Addendum No. C

To the contract documents for NORTH VERDEMONT ELEMENTARY SCHOOL, DSA No. 04-122168

For the SAN BERNARDINO CITY SCHOOL DISTRICT

LPA Project No.: 30899

PLANTING PLAN ENLARGEMENT 1" = 10'-0" 07

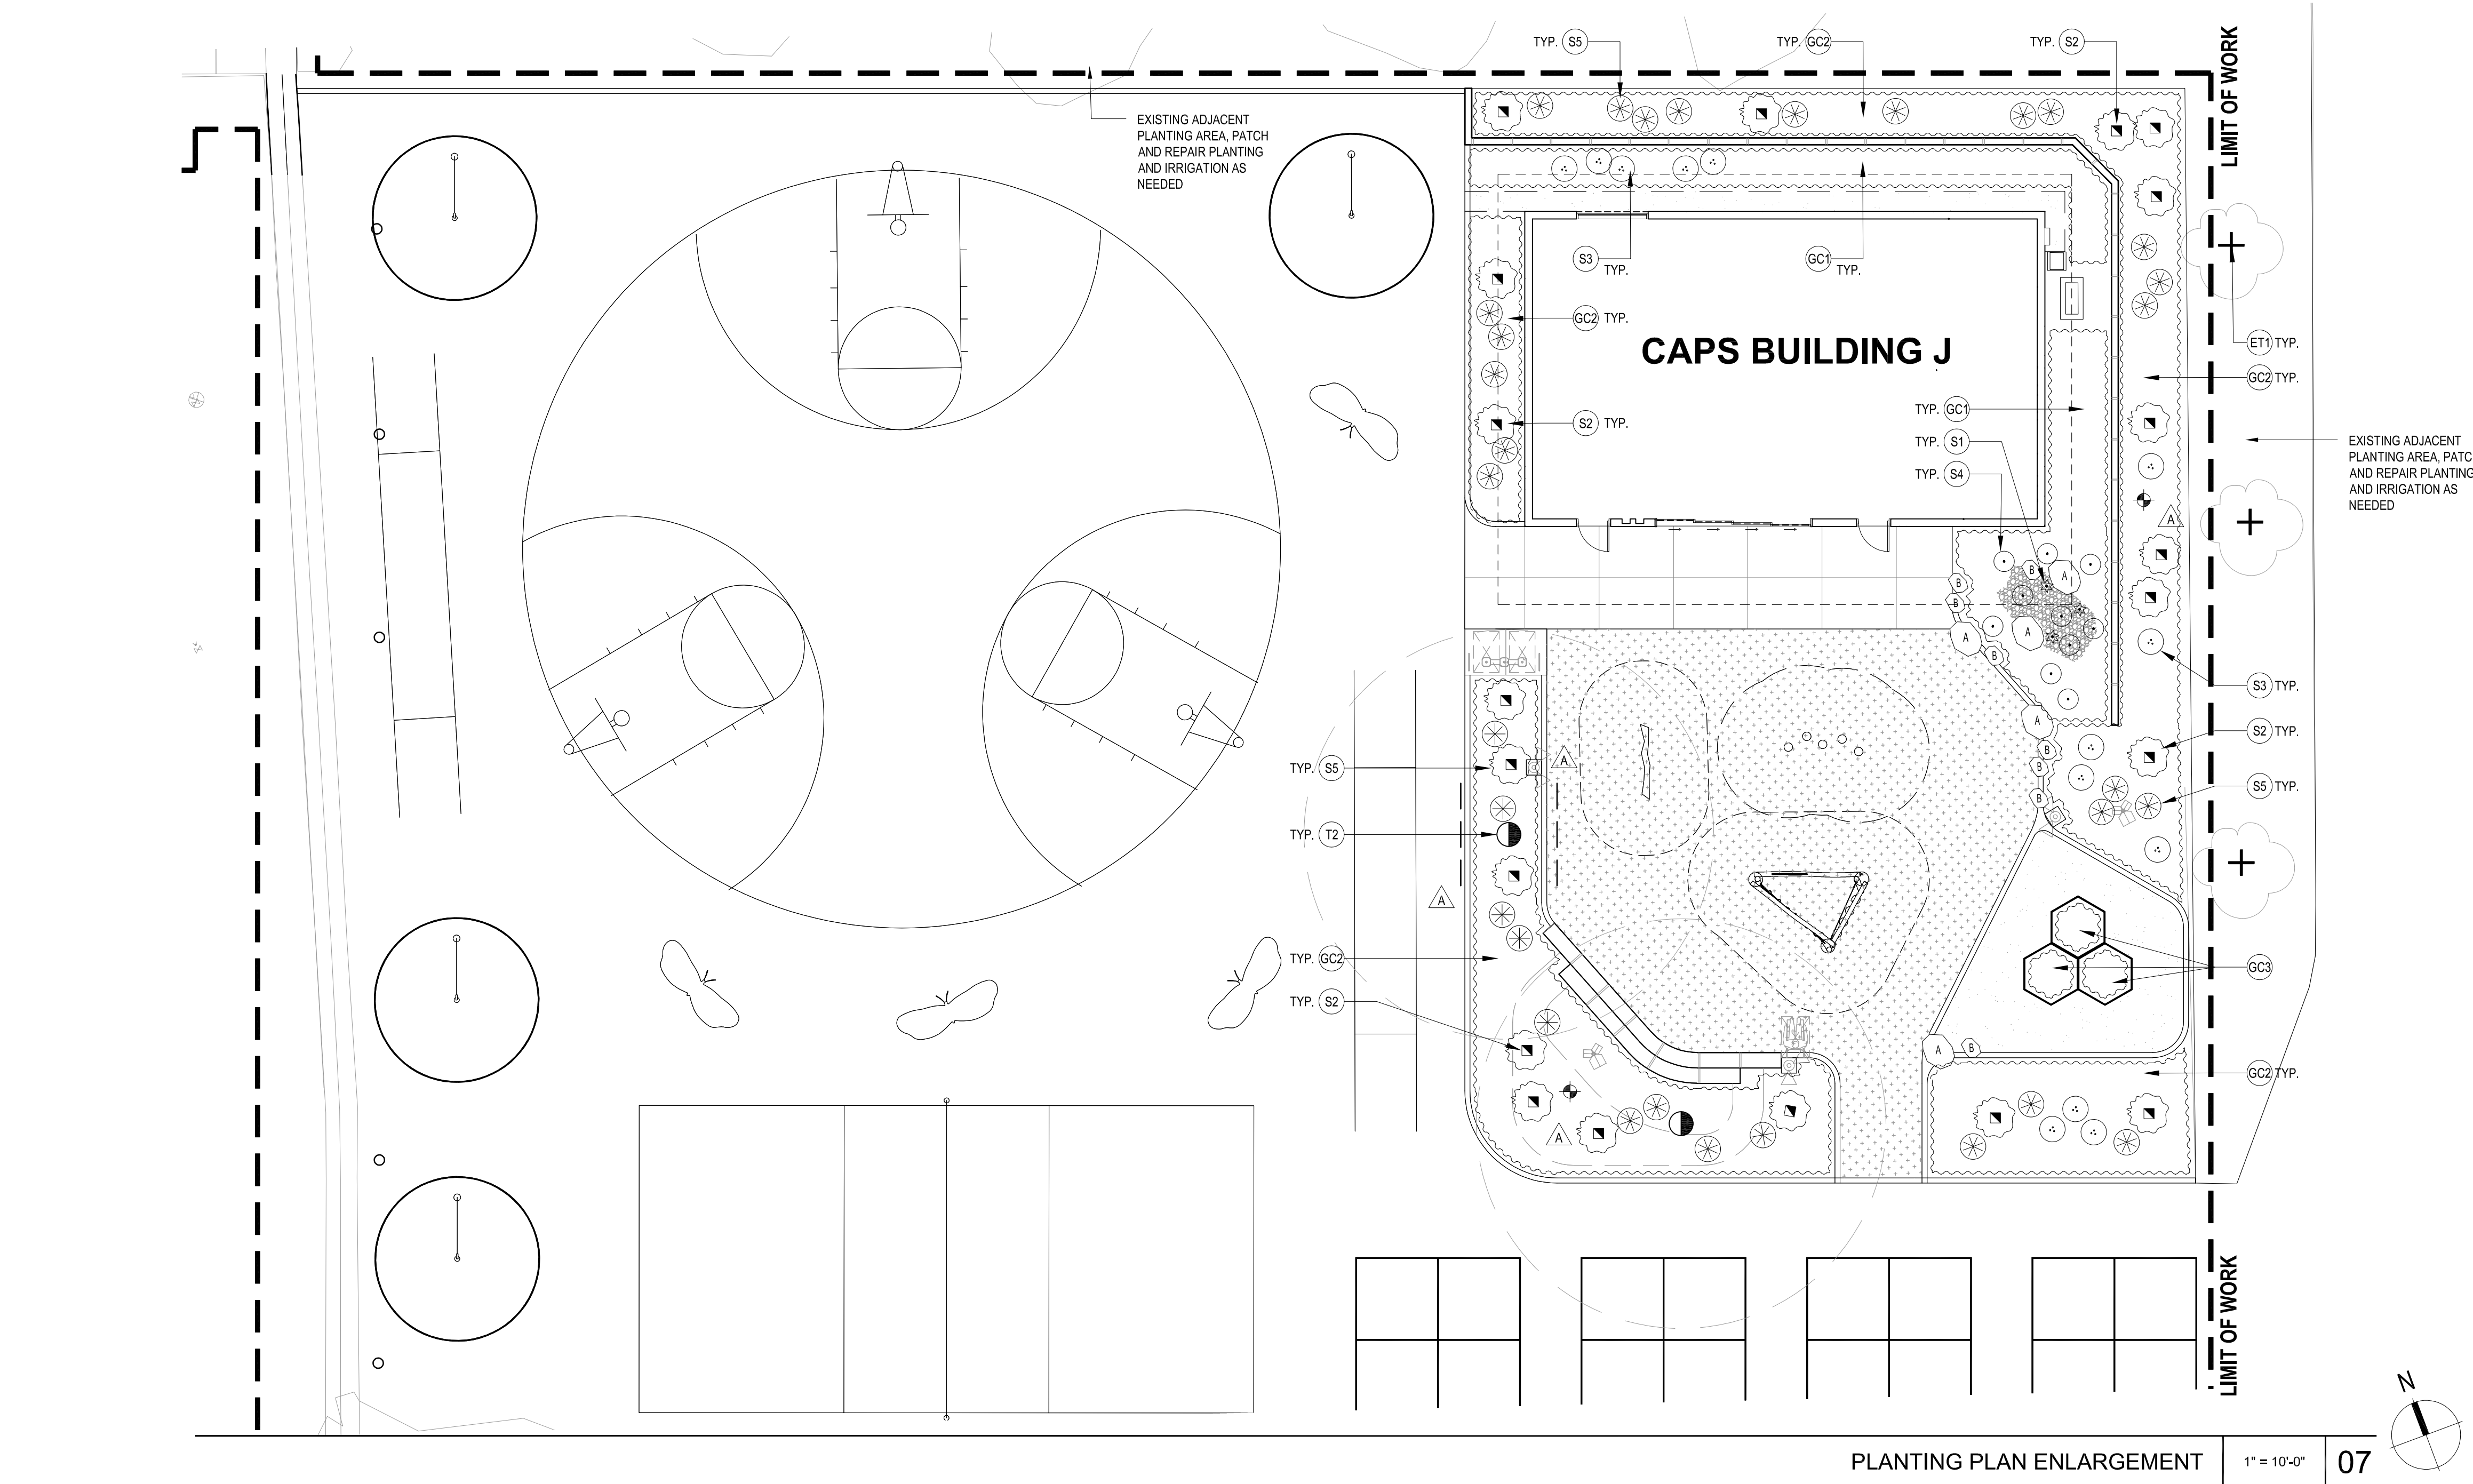
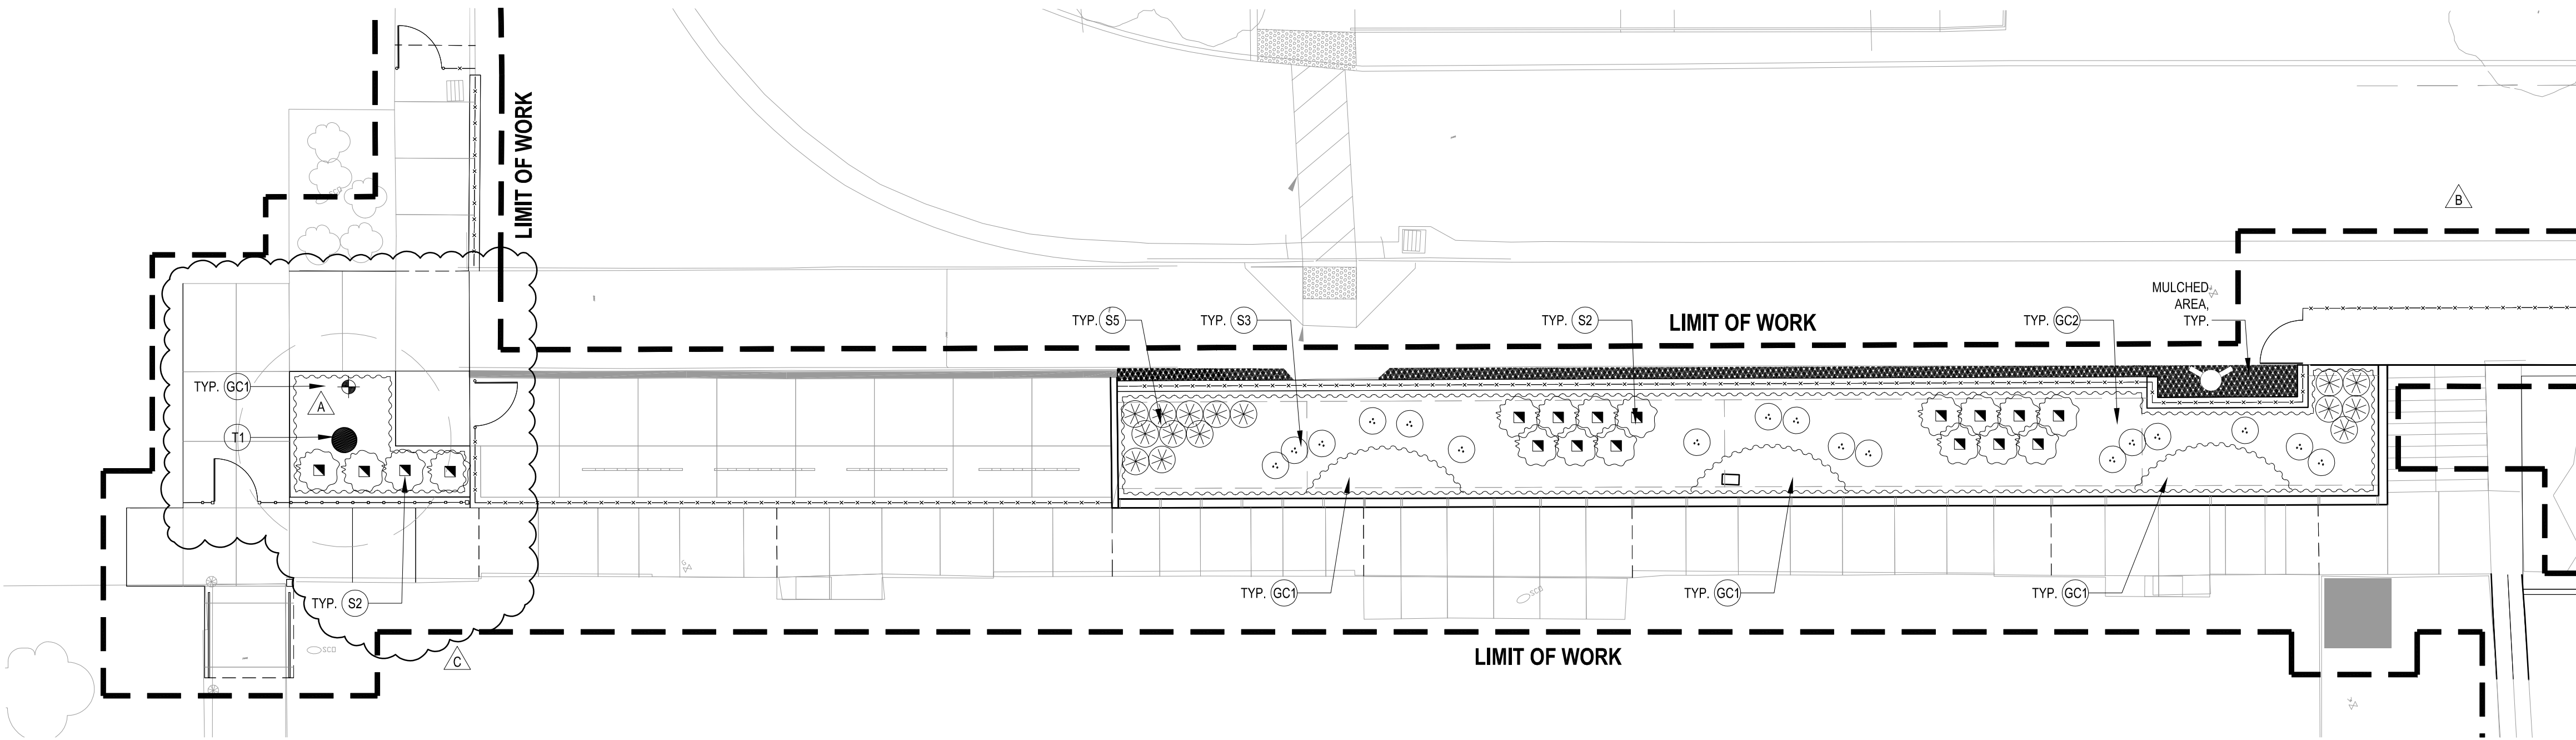
- Item No. 19** L7.01 – Planting Plan  
a) Revised planting at entry.
- Item No. 20** E1.10 – ELECTRICAL AND LIGHTING SITE PLAN  
a) Relocated location of comm box due to door location revision  
b) Added low voltage conduit routing for clarity
